RE: **Drive Thru Restaurant**  
**700 Coors Blvd NW**  
**Grading Plan Stamp Date: 5/15/20**  
**Hydrology File: J11D039**

CESO, Inc. is pleased to submit this letter to you in response to your previous review letter dated 09/23/2019.

Drawing No. **GD1.0**

Drawing No. GD1.1

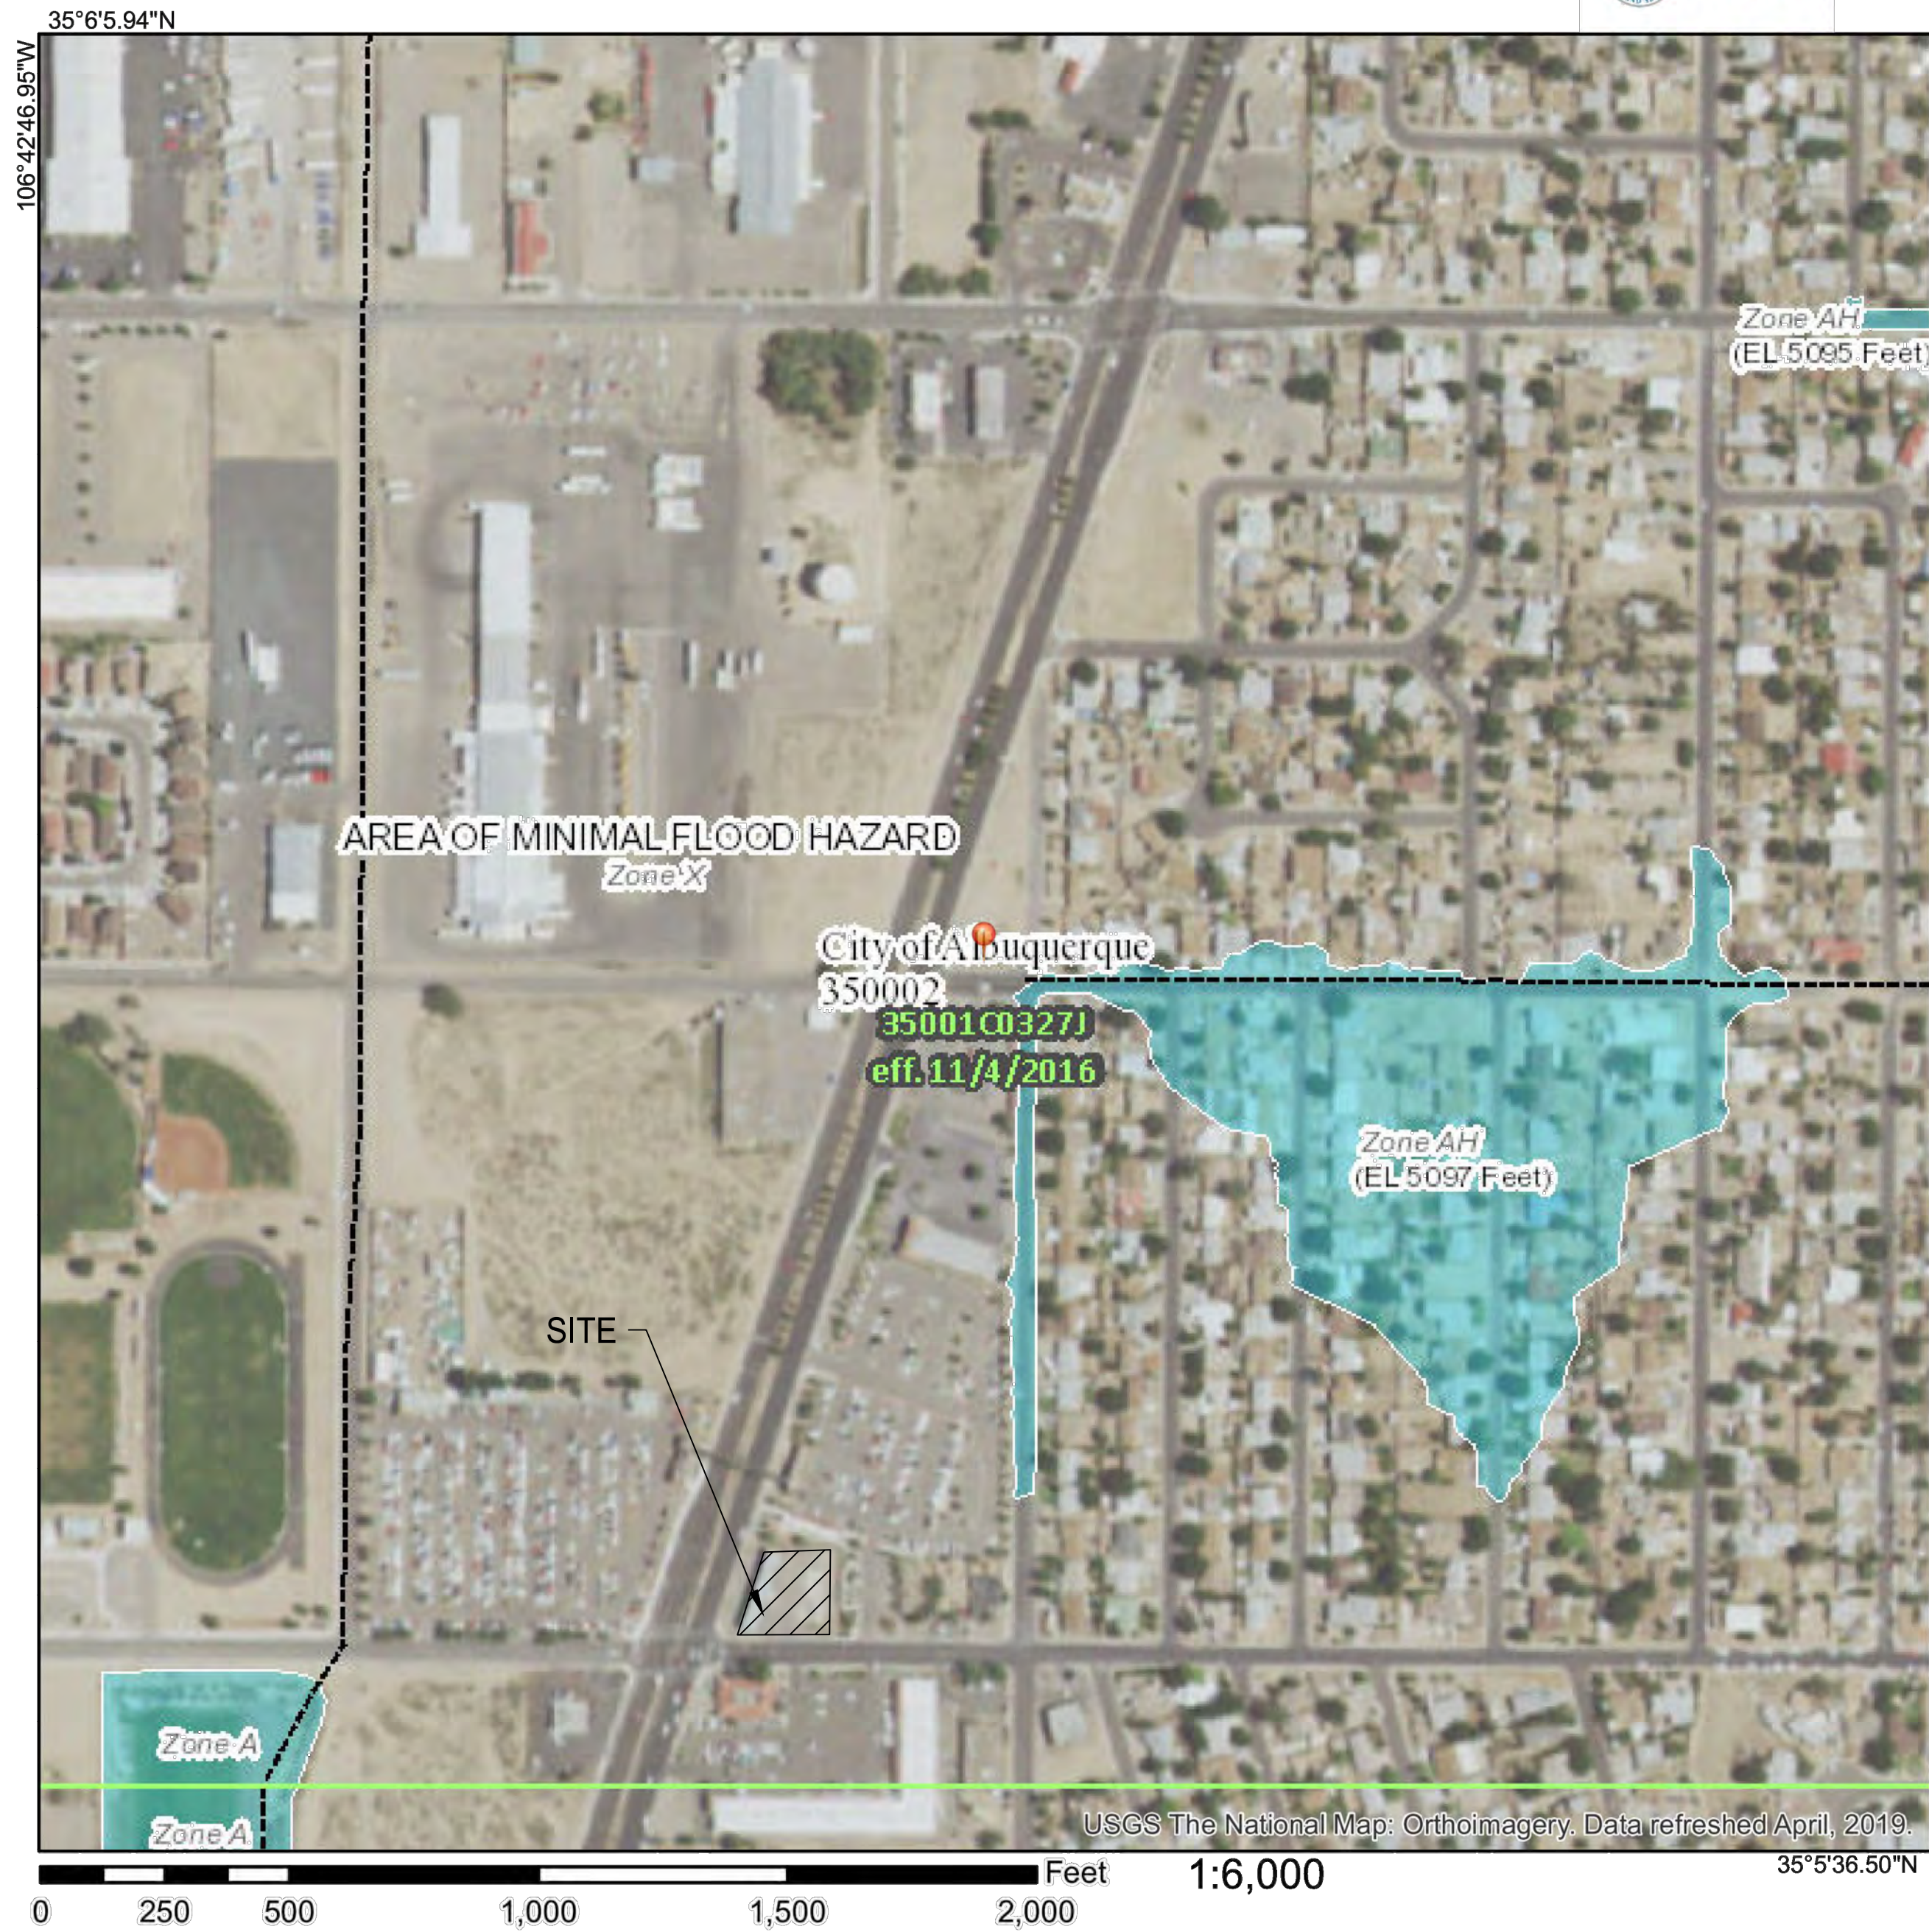
3. Provide hydrologic calculations per the DPM, Ch 22.2.A for the 100-yr storm. Also, a brief narrative describing the project and existing/proposed grading and drainage is recommended (DPM Ch 22.7: *Grading Plan Checklist*).

4. Provide outfalls for both ponds, sized for the 100-yr peak inflow. Include supporting hydraulic calculations as needed.

**Response: This has been added to the plans on Sheet GD1.1.**

**Response: The ponds are designed as retention ponds to provide rainwater harvesting. Hydraulic calculations are provided on Sheet GD1.1.**
